LANDMARKS COMMISSION AGENDA

A. HI-21-25/SP-20-25/RL-09-25, Type III- Quasi-Judicial Process [Page 7 – Page 102]

Summary: Historic Review of New Construction for a four-story mixed-use building of approximately 27,000 square feet with 37 units, a Site Plan Review for New Construction, and a Replat to consolidate the properties into one lot. The property is located at 300 1st Ave SW.

Historic Review for New Construction, Site Plan Review for New Construction, and Tentative Replat

Sheet C1.3

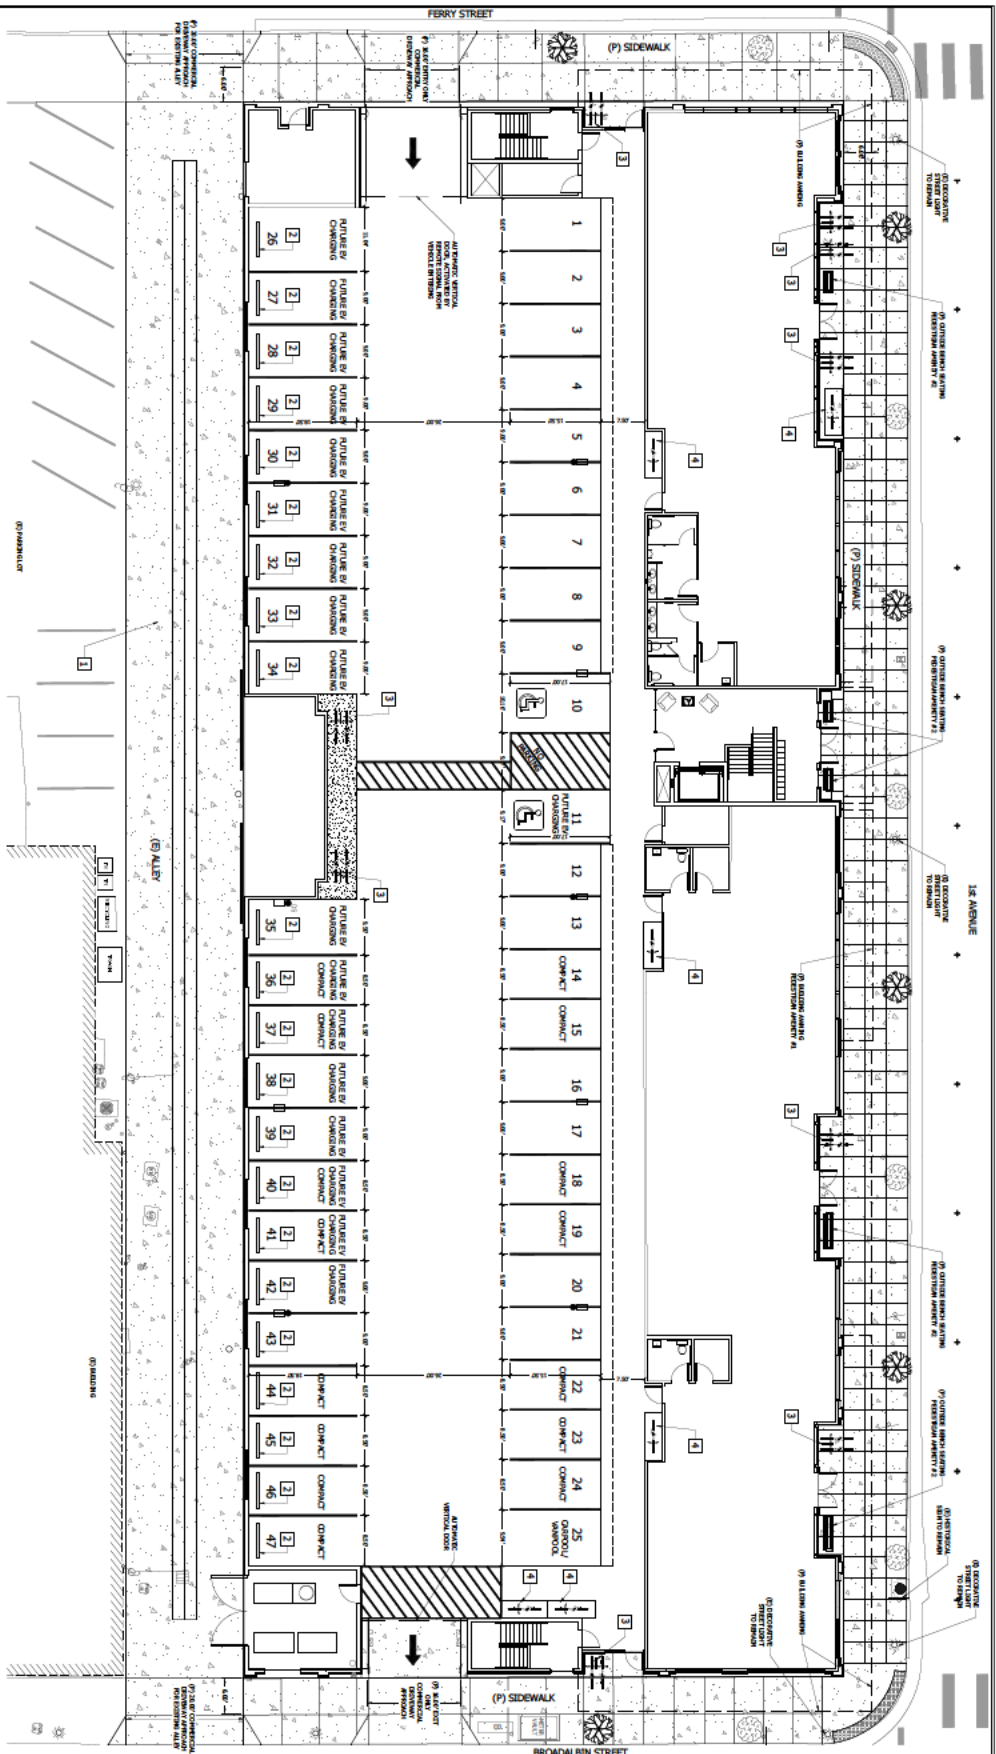
Revised Sheets C1.3 and C1.4 show the revised 26' wide one-way driveway to meet ADC 12.100, including an automatic vertical overhead door system with which the product data information has been provided for review. See Exhibit H for Cookson Door Extreme Microcoil Grille information.

Revised Sheets C1.3 and C1.4 depict the reconfigured parking spaces to allow for adequate backing out and clearance requirements to comply with ADC 9.120.

Revised Sheets C1.3 and C1.4 illustrate the reduced column sizes which provide an increase in the clear width between parking stalls.

Revised Sheets C1.3 and C1.4 note the included alley improvements that comply with current City standards, as referenced in ADC 12.060(2).

Revised Sheets C1.3 and C1.4 show the updated locations of covered bicycle parking near the building entrances, with dimensions that are compliant with Table 9.030-2.
